UNITED STATES PATENT AND TRADEMARK OFFICE

| APPLICATION NO. | FILING DATE | FIRST NAMED INVENTOR | ATTORNEY DOCKET NO. | CONFIRMATION NO. |
|-------------------------------|-------------|----------------------|---------------------|------------------|
| 10/574,617 | 04/05/2006 | Naoto Yokoyama | 0033-1073PUS1 | 2104 |

Office Action Summary

DETAILED ACTION

FIG.2

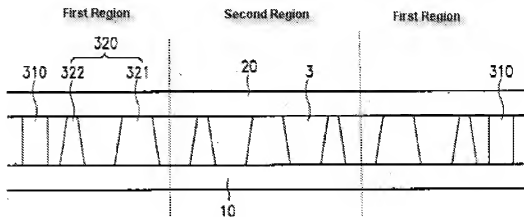
3. Claim 4 is rejected under 35 U.S.C. 102(e) as being anticipated by Cho et al. (US 20040114087).

Regarding claim 4, Cho discloses a liquid crystal display panel comprising: two substrates (10, 20) fixed together by a seal member (310) with their main surfaces opposed to each other; liquid crystal (3) sealingly stored in a region surrounded by said two substrates and said seal member and a plurality of columnar spacers (320) arranged in the region surrounded by said two substrates and said seal member, wherein said columnar spacers include: a first columnar spacer (321), and a second columnar spacer (322) being higher than said first columnar spacer when receiving no load; said first columnar spacer is arranged in a first region near an inner side of said seal member and a second region located inside said first region; and said second columnar spacer is arranged in said second region (Fig. 2 below and Fig. 3).
